BID/ RFP ADDENDUM No.2
DATE: 08/16/2023
BID/RFP No: 2022-19
BID NAME: Vocational Building Remodel

ADDENDUM NO. 02

CAREER TECHNICAL EDUCATION BUILDING RENOVATION
Merced, CA

The following additions, deletions, and revisions to the SHEETS and Project Manual are hereby made and do become a part of these Contract Documents.

AD2-MX02

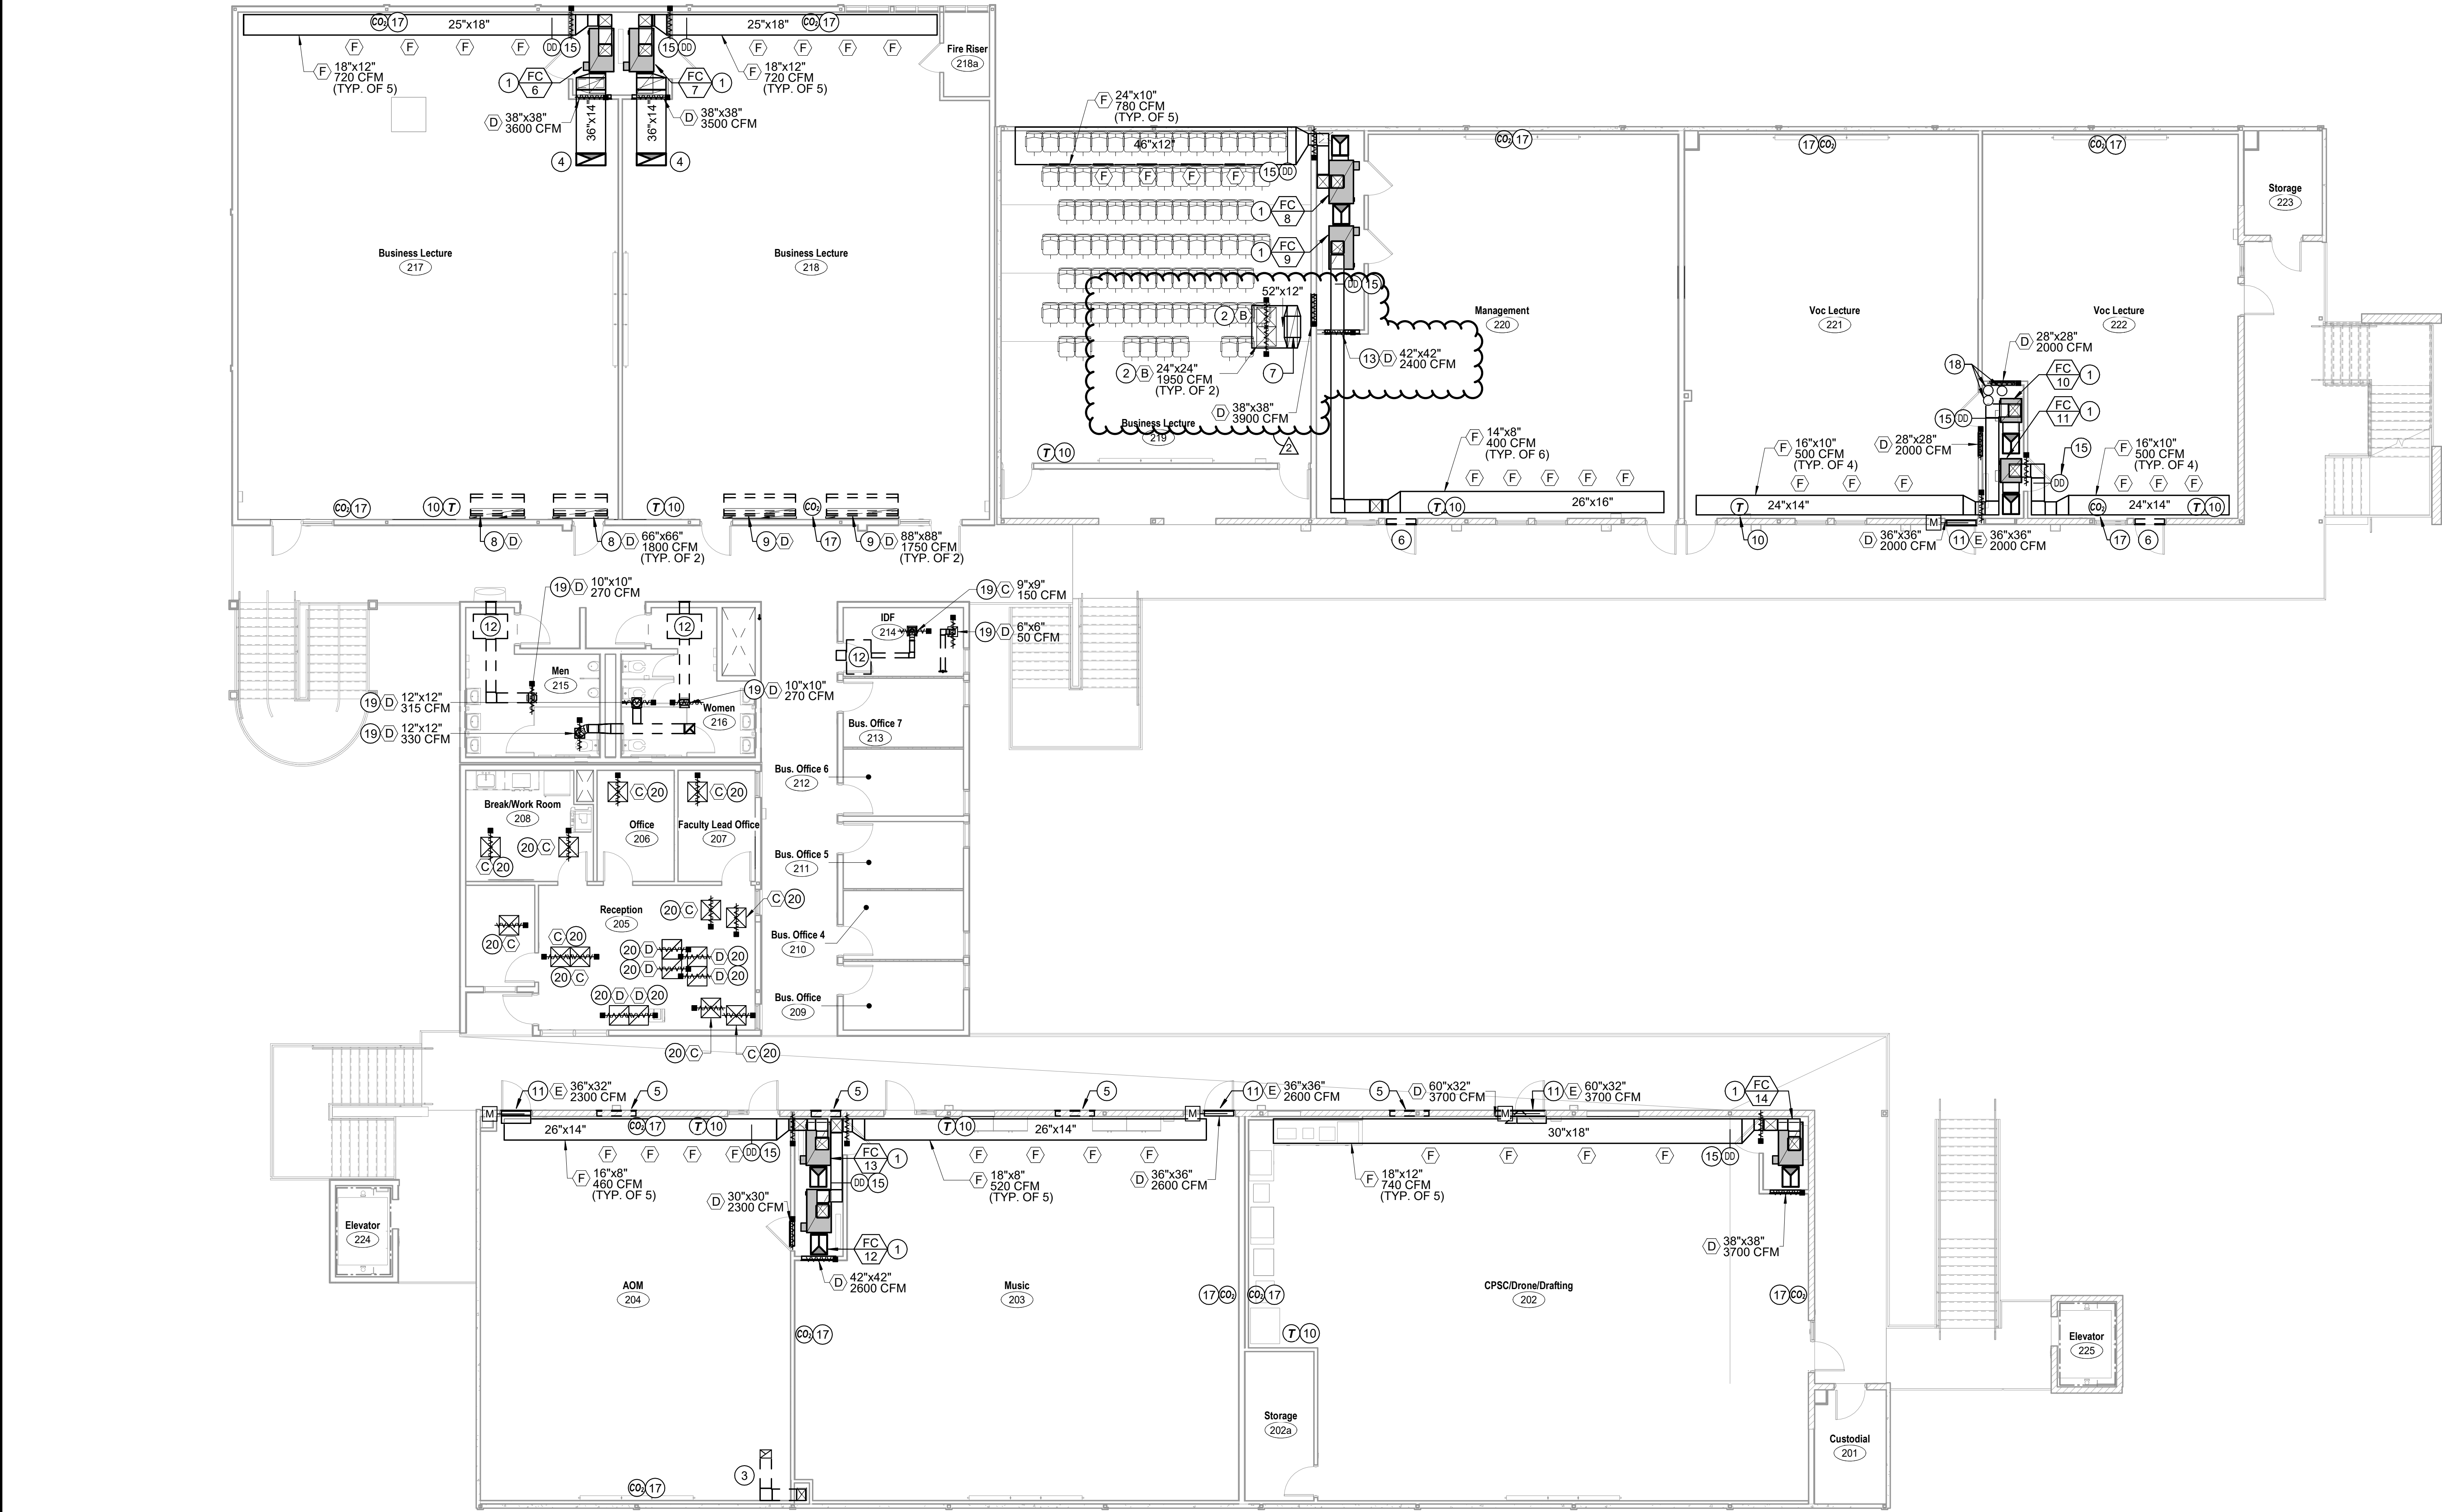
AD2-M02 Refer to Sheet A/M101, MECHANICAL PLAN – FIRST FLOOR:

1. Replace sheet with attached sheet A/M101, MECHANICAL PLAN – FIRST FLOOR with AD2-MX02 in the lower right corner. Changes are in the clouded area(s).

FIRST FLOOR HYDRONIC PIPING PLAN

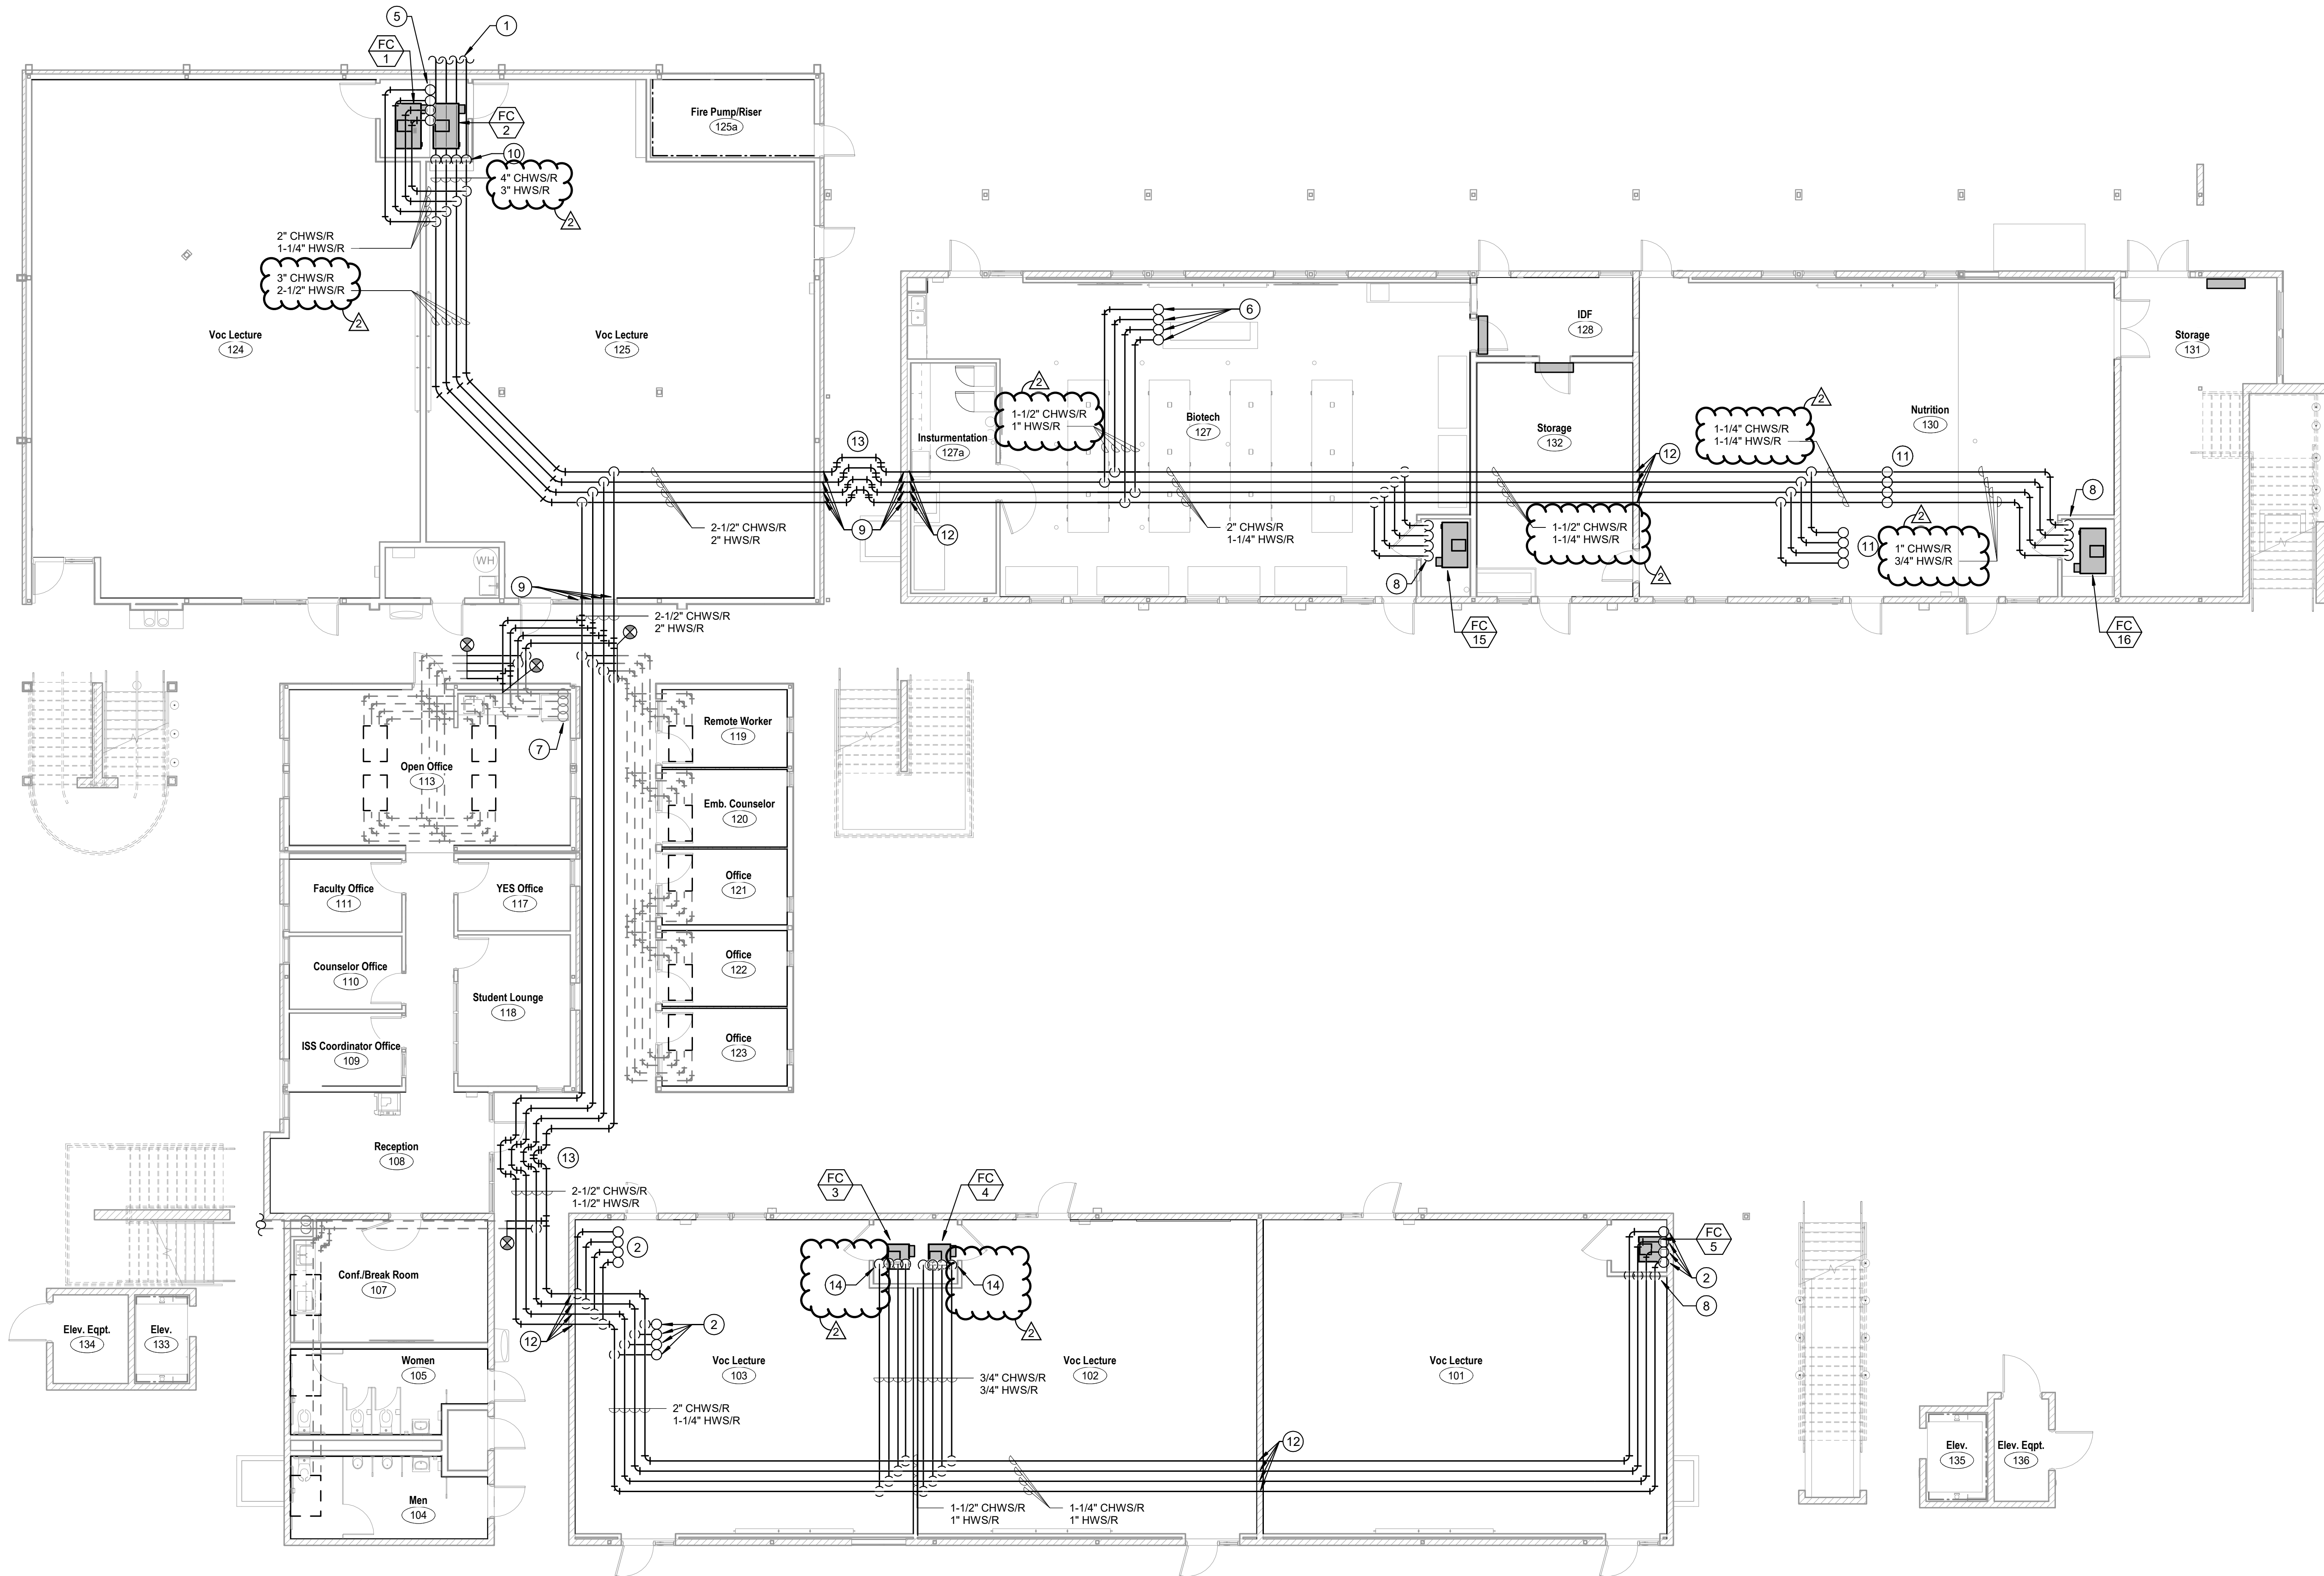
AD2-M04 Refer to Sheet A/M201, FIRST FLOOR HYDRONIC PIPING PLAN:

1. Replace sheet with attached sheet A/M201 FIRST FLOOR HYDRONIC PIPING PLAN with AD2-MX04 in the lower right corner. Changes are in the clouded area(s).

AD2-MX05

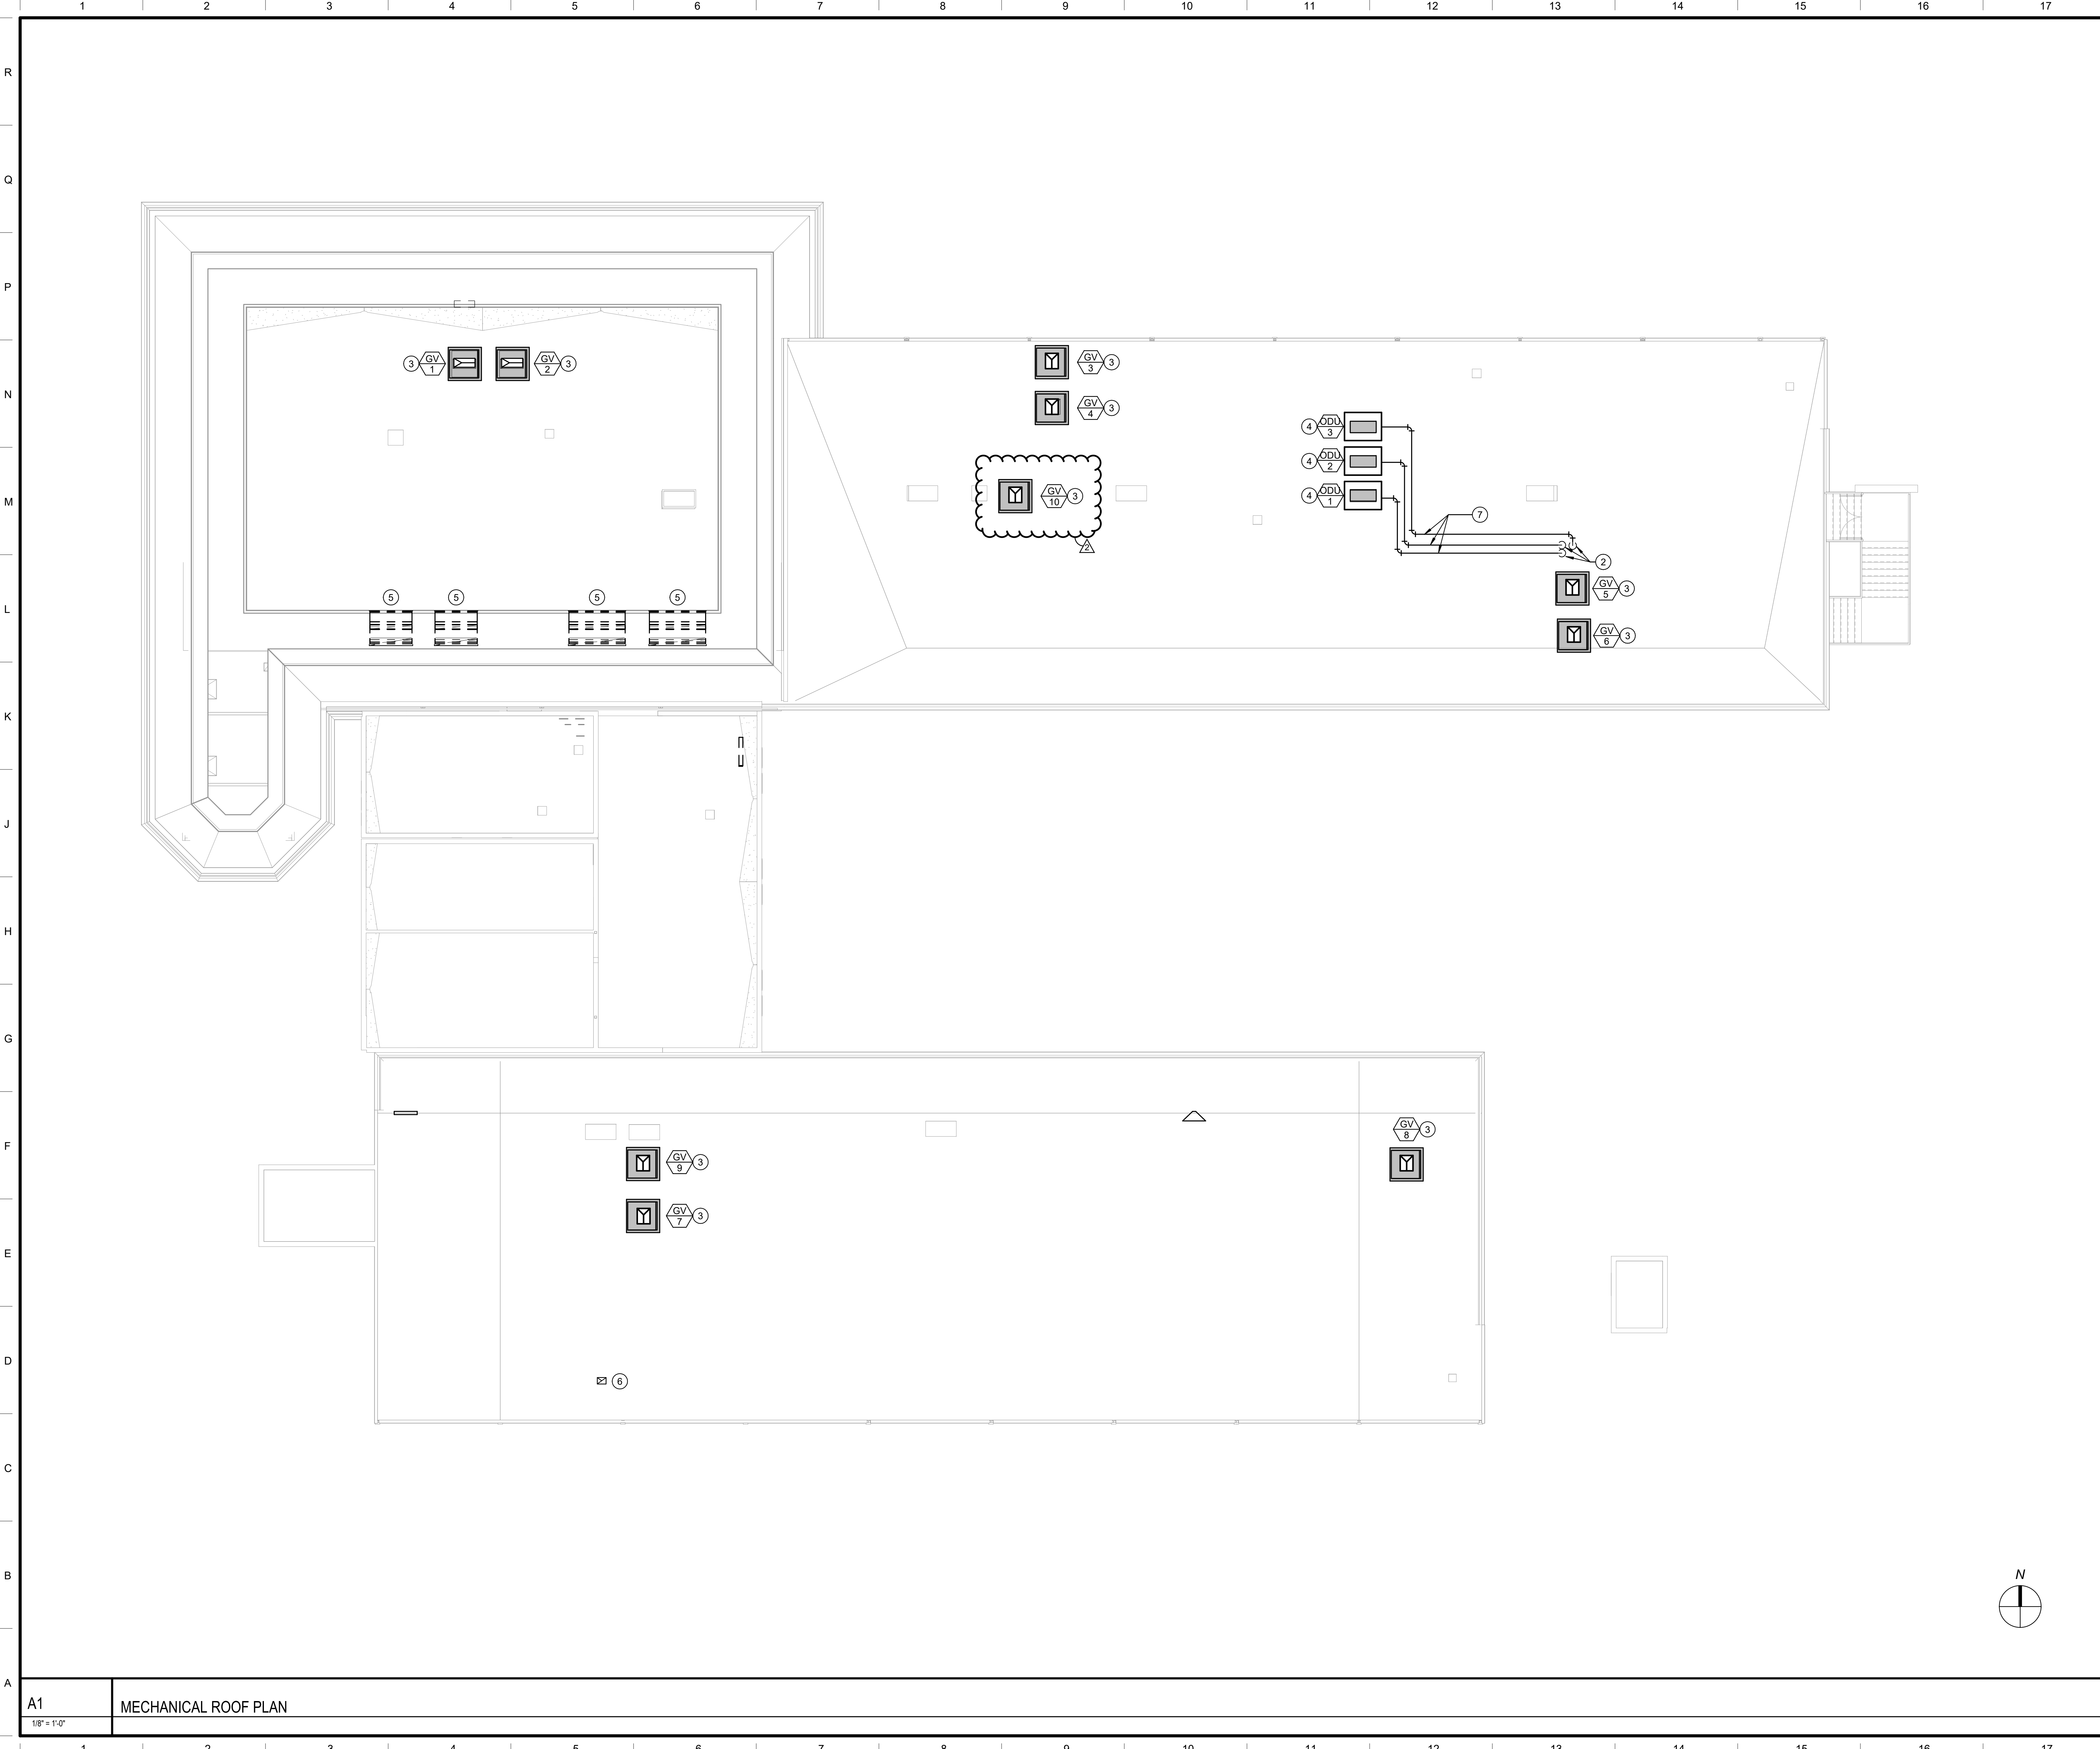
AD2-M05 Refer to Sheet A/M202, SECOND FLOOR HYDRONIC PIPING:

1. Replace sheet with attached sheet A/M202 SECOND FLOOR HYDRONIC PIPING with AD2-MX05 in the lower right corner. Changes are in the clouded area(s).
